LRN-02-0394

**REQUEST FOR ADDITIONAL INFORMATION
INSERVICE INSPECTION PROGRAM RELIEF REQUEST
S1-RR-B01
SALEM GENERATING STATION- UNIT 1
FACILITY OPERATING LICENSE DPR-70
DOCKET NOS. 50-272**

Pressurizer Relief
and
Pressurizer Spray Lines
Nozzle
to
Safe-end
Weld Configurations

Weld Configurations

TITLE: 6-IN SCH. 160 SAFETY & RELIEF NOZ. (CAST 111-C)

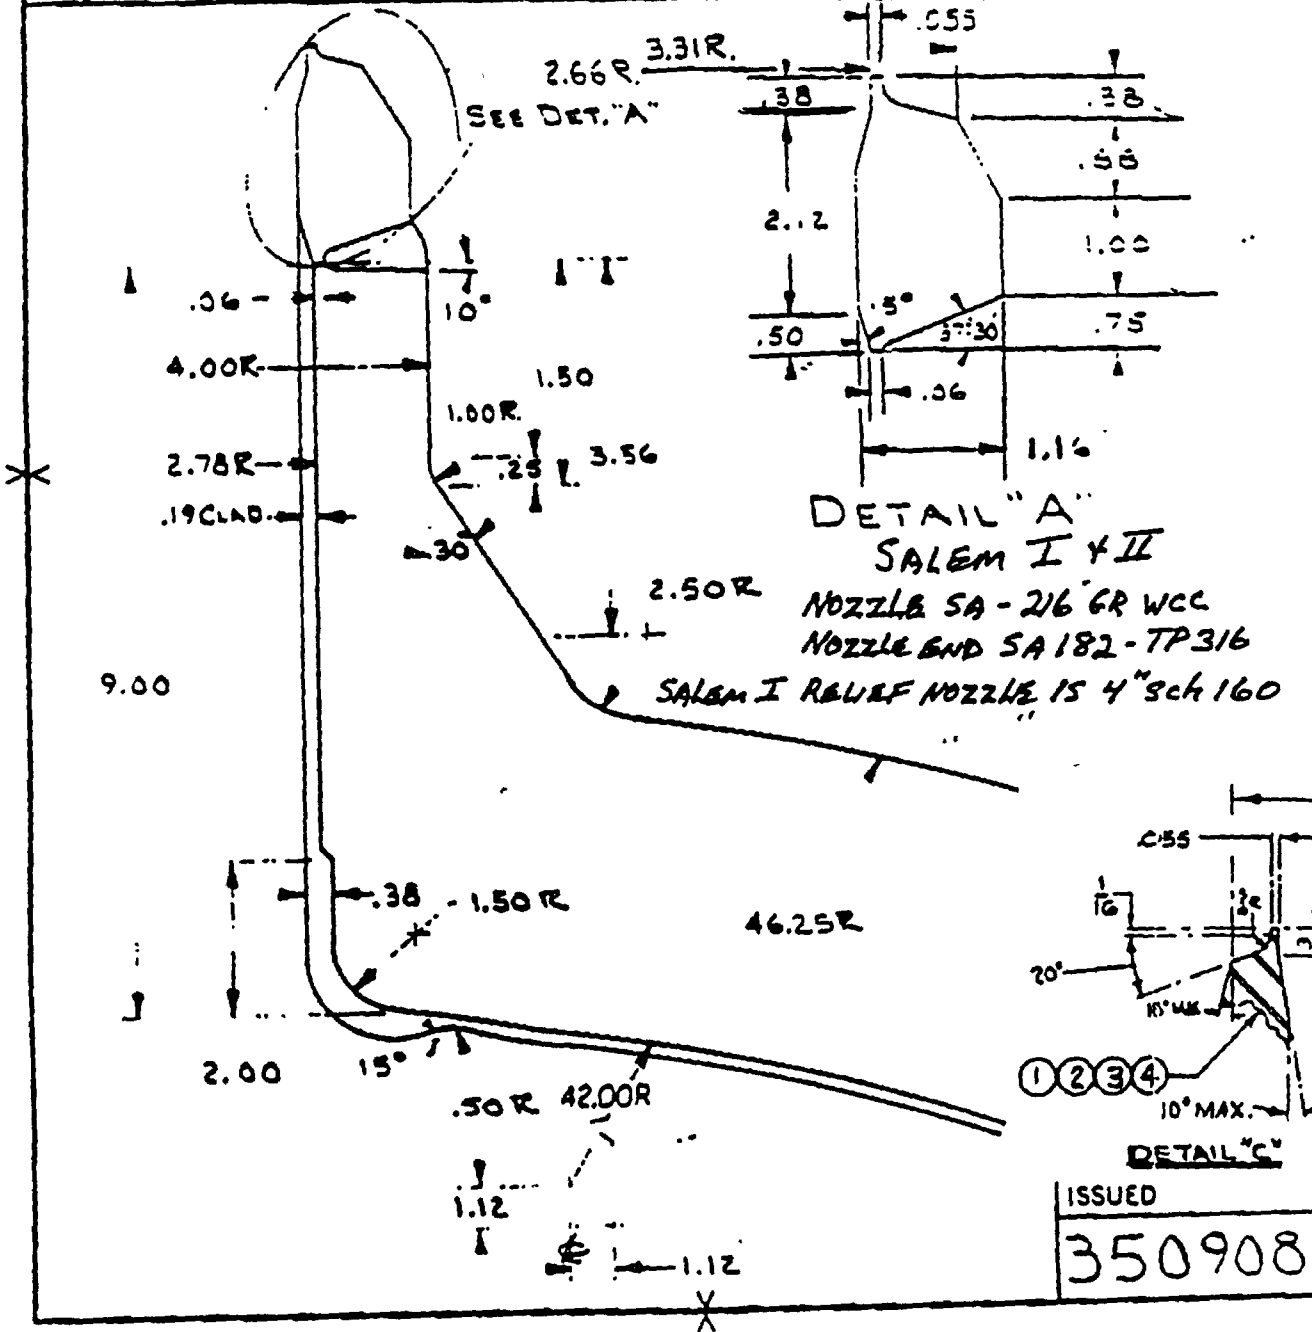
The Pressurizer relief and spray line 'nozzle to safe-end' welds 6-PR-1104-1 (Summary No. 023400), 6-PR-1103-1 (Summary No. 024600), 4-PS-1131-29 (Summary No. 033500) and 4-PR-1100-1 (Summary No. 025900) do not contain Alloy 600 type material as evidenced by Attachment 1 drawing and information.

WESTINGHOUSE ELECTRIC CORPORATION TAMPA DIVISION TAMPA FLA
 TITLE: PRESSURIZER SPRAY NOZZLE (CAST HEAD)

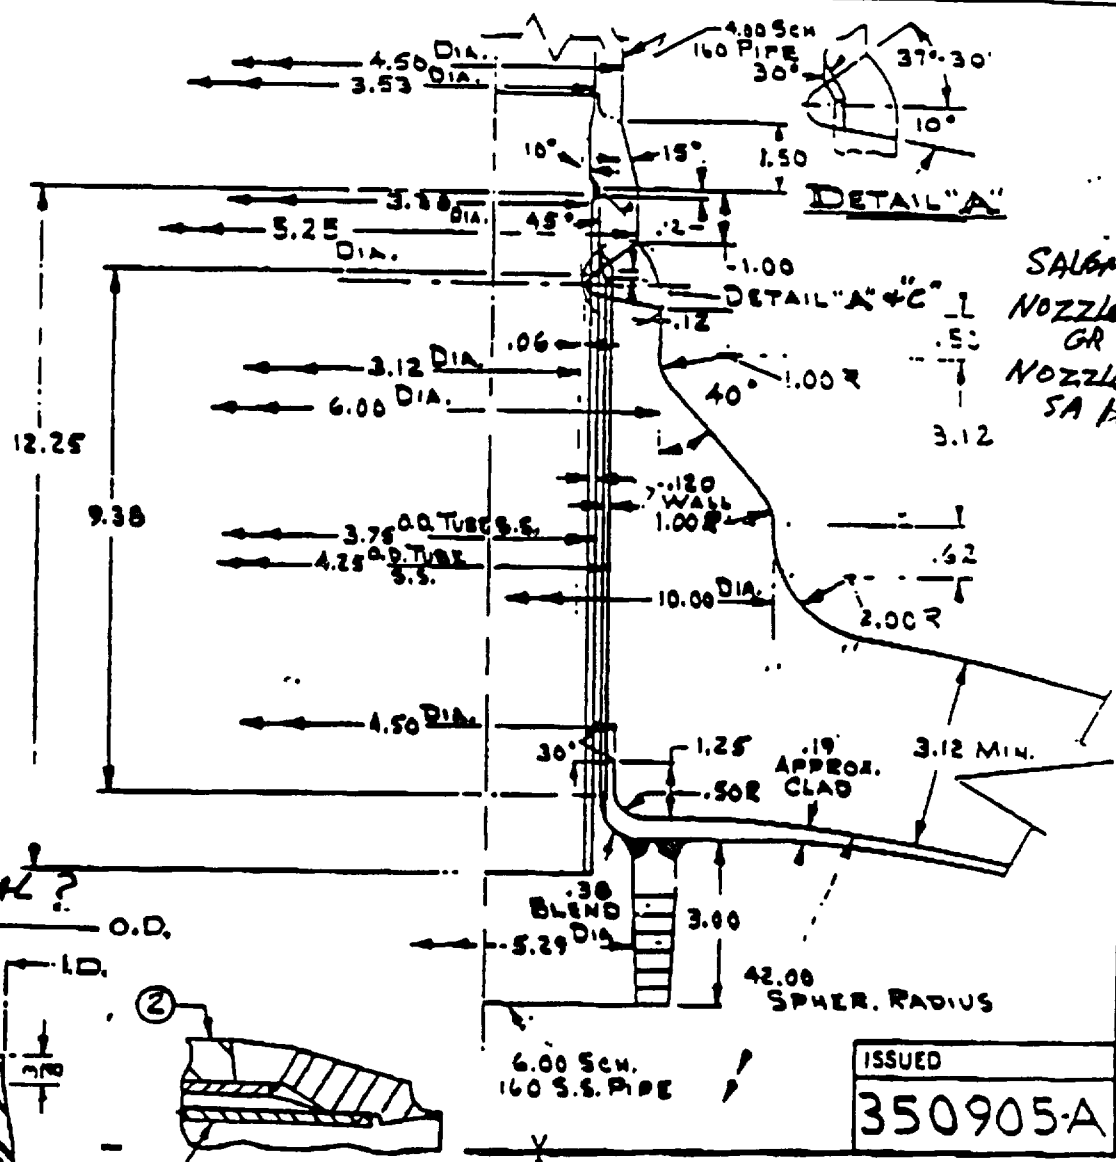
WELD MATERIAL?

SALEM I S/G REPLACEMENT PRIMARY NOZZLE W 4 LOOP MODEL "F"

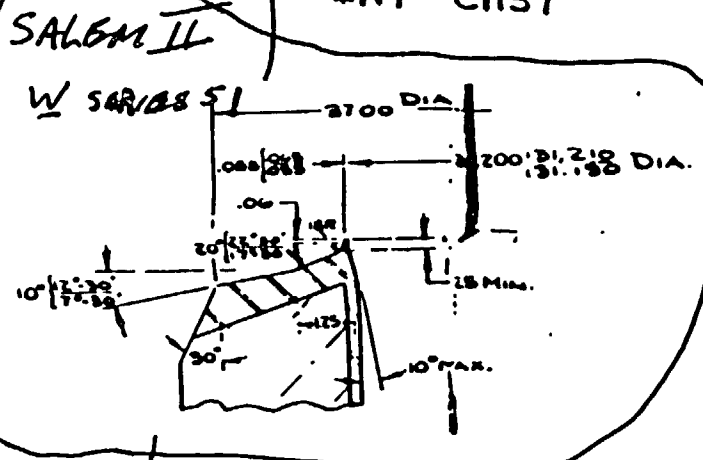
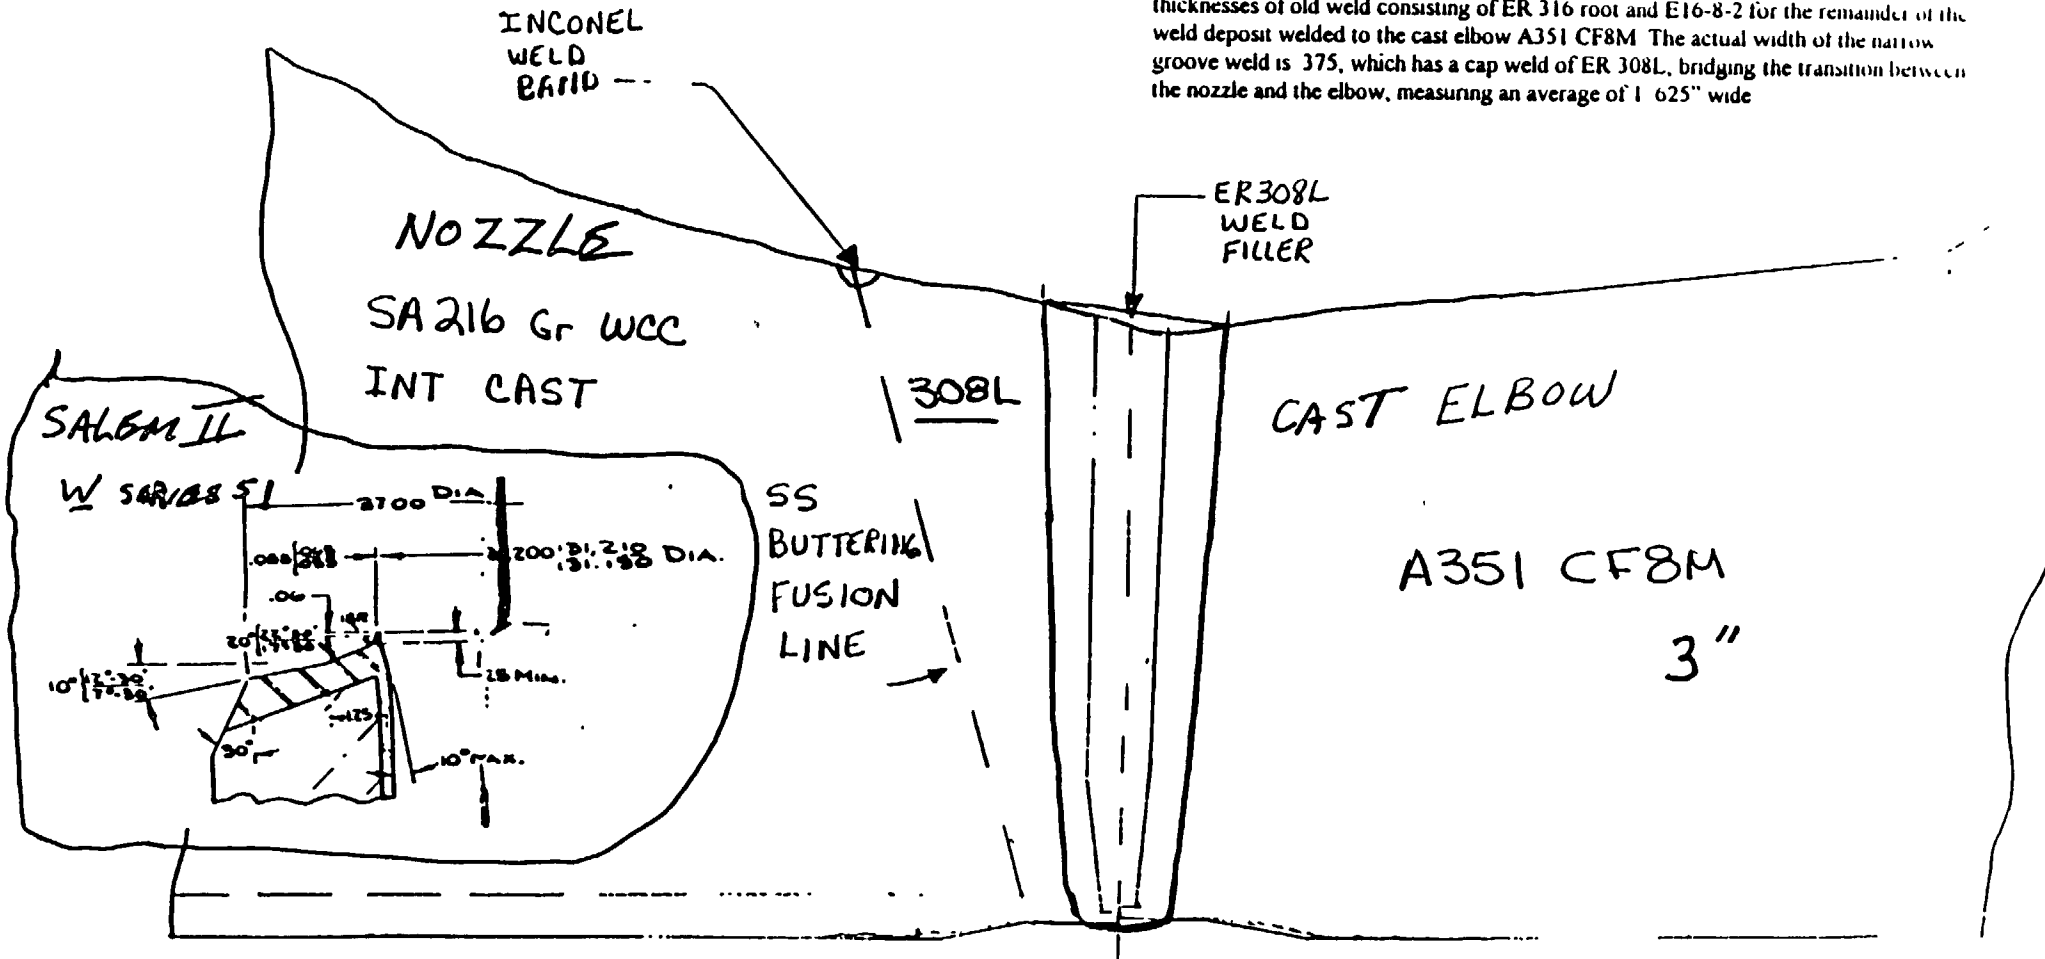
The Steam Generator nozzle-to-elbow welds 31-RC-1130-2R1 (Summary No. 039200), 29-RC-1130-5R1 (Summary No. 050210), and 29-RC-1120-5R1 (052600) contain a single bead of Alloy 600 material located on the outside of the pipe. The Alloy 600 material is not in contact with the primary reactor water coolant located on the inside of the piping as evidenced by Attachment 2 drawing and information.

The new welds consists of SA 216 Gr WCC cast nozzle, Inconel weld band 308L old weld from the hydro cap welded at Seabrook, 308L narrow groove weld, various thicknesses of old weld consisting of ER 316 root and E16-8-2 for the remainder of the weld deposit welded to the cast elbow A351 CF8M. The actual width of the narrow groove weld is .375, which has a cap weld of ER 308L, bridging the transition between the nozzle and the elbow, measuring an average of 1.625" wide
